SAFETY EVALUATION BY THE OFFICE OF NUCLEAR REACTOR REGULATION

SUPPORTING AMENDMENT NO. 89 TO FACILITY OPERATING LICENSE NO. DPR-65

MILLSTONE NUCLEAR POWER STATION, UNIT NO. 2

DOCKET NO. 50-336

FIGURE 1

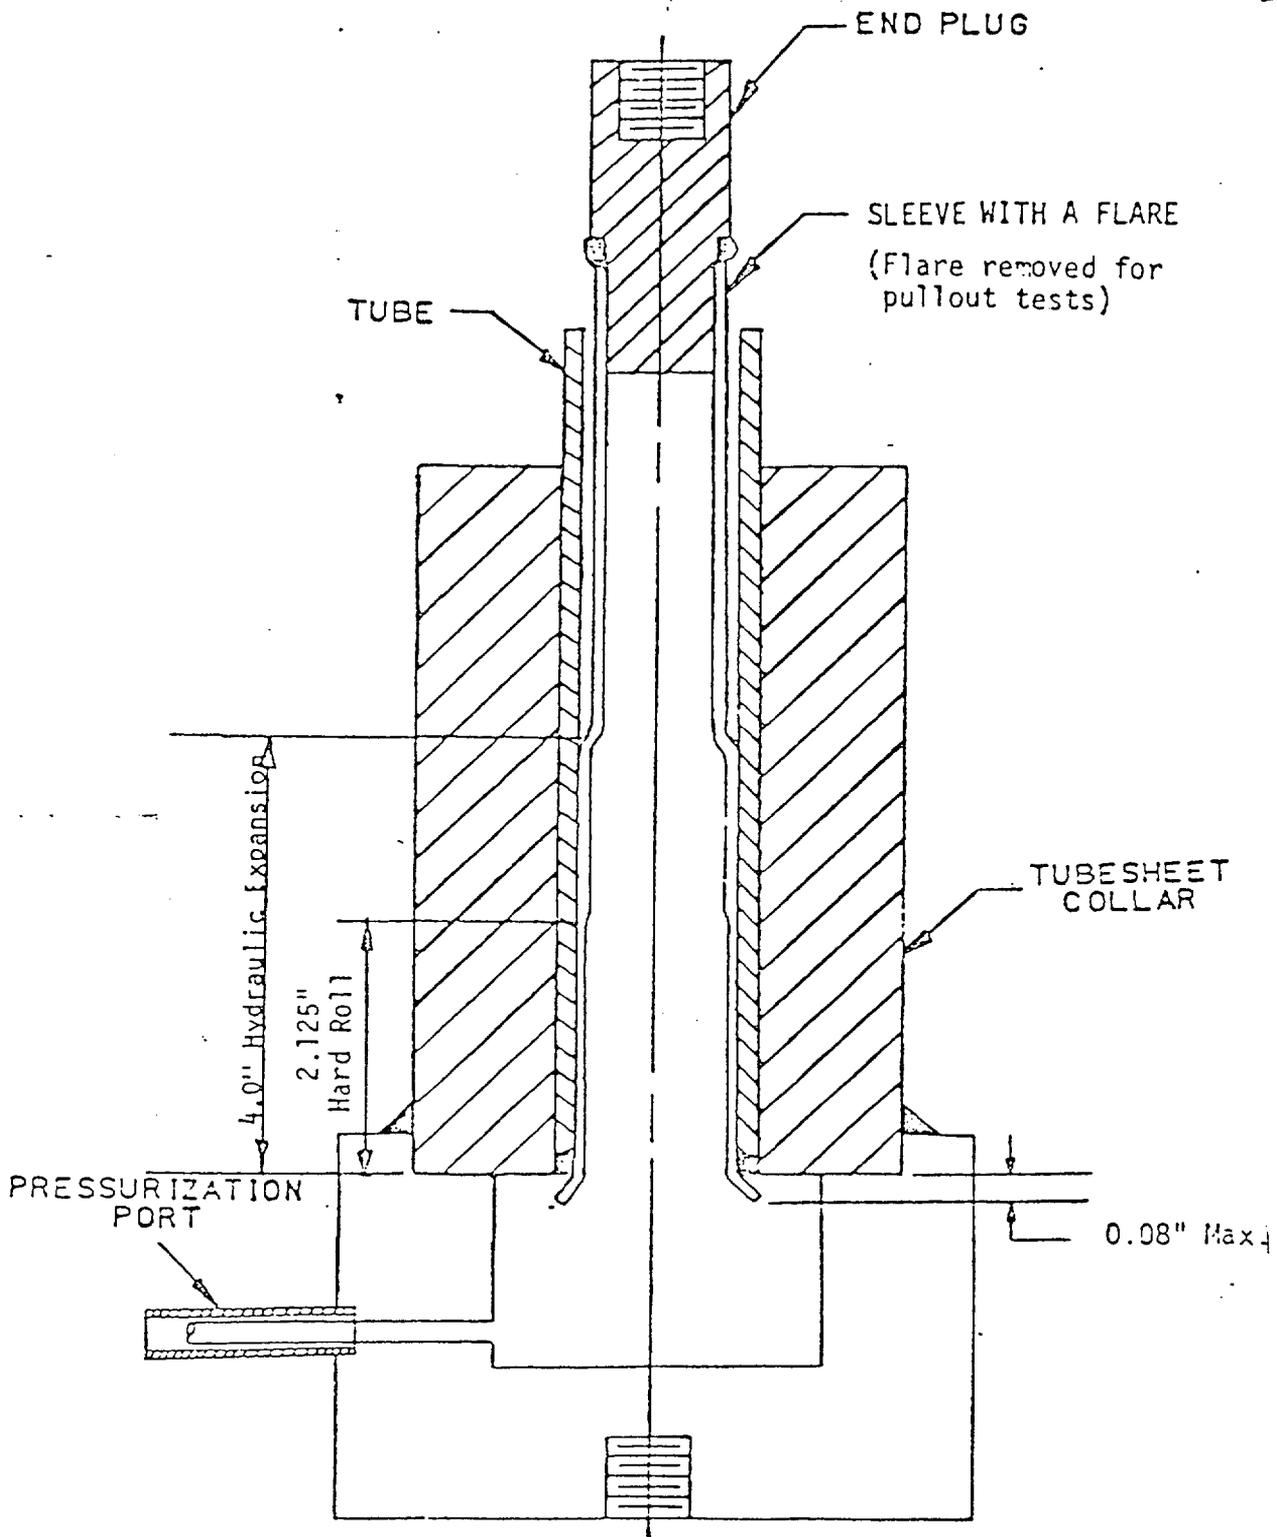
[The lower joint shown in Figure 1 consisted of a short length of Inconel 600 tubing expanded and welded to the collar which simulated the tubesheet. The tube expansion was accomplished by hard rolling and/or hydraulic expansion to simulate the full depth explosive expansion that was used in Millstone Unit 2. The collar was not clad on the end with Inconel 600, as are the Millstone Unit 2 steam generator tube sheets. Previous testing with this type test specimen has indicated that the Inconel 600 clad is not critical to the successful fabrication of the joint.]

[A short length of sleeve was inserted into the tube/collar, hydraulically expanded, and was then hard rolled to make a lower joint specimen. This specimen was then subjected to a series of tests that included leak resistance, pull-out and push-out strengths, thermal cycling, fatigue strength and metallographic examination. These dependent variables were determined as functions of the hydraulic expansion pressure, the sleeve hard rolling torque and the sleeve material.]

FIGURE 2

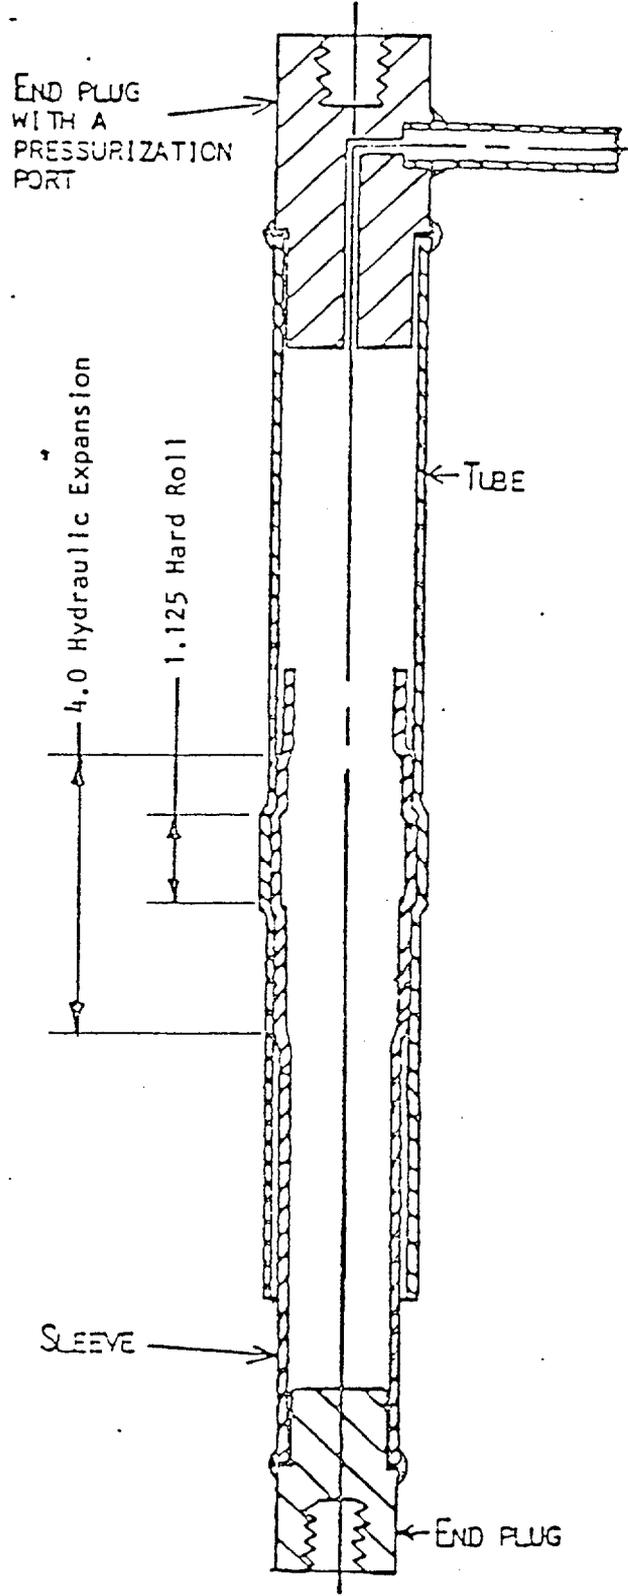
[The upper joint, shown in Figure 2, consisted of a piece of sleeve material fastened into a piece of Inconel 600 tube. The sleeve was first hydraulically expanded against the inside of the tube over a short length. It was then hard roll expanded against the tube over a length within the hydraulically expanded length. This joint is called a hybrid expansion joint (HEJ) because of the combination of hydraulic and mechanical expansion.]
